SAFETY ALERT

Trim Tab Reinforcement

SA-SECS-CTSW-03

Technical Advice No.13 – revision 2

Fig B1 & B2: Reinforcement installed to the trim tab
(Tab shown bottom surface facing up)

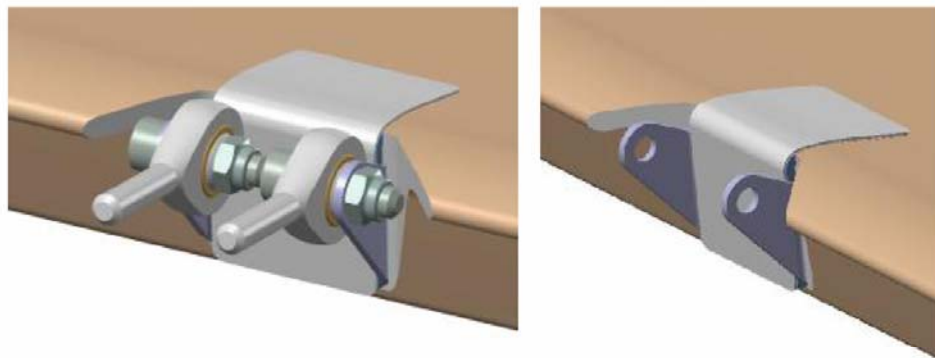
The reinforcement procedure consists of reinforcing the point at which the control horn is bonded to the trim tab by the addition of specifically designed part manufactured by Flight Design (WA 3011011). The part is glued (bonded) to the control rod bracket and the lower trim tab surface and delivers a secondary load path for the trim tab control forces. The modification can be done without removing the trim tab, and does not require painting action. (Figs.B1 & B2)

The procedure shall be completed according to Flight Design document: "070625 – TRIM TAB REINFORCEMENT PROCEDURE" that accompanies this Safety Directive, and supplemented by the Maintenance Manual.
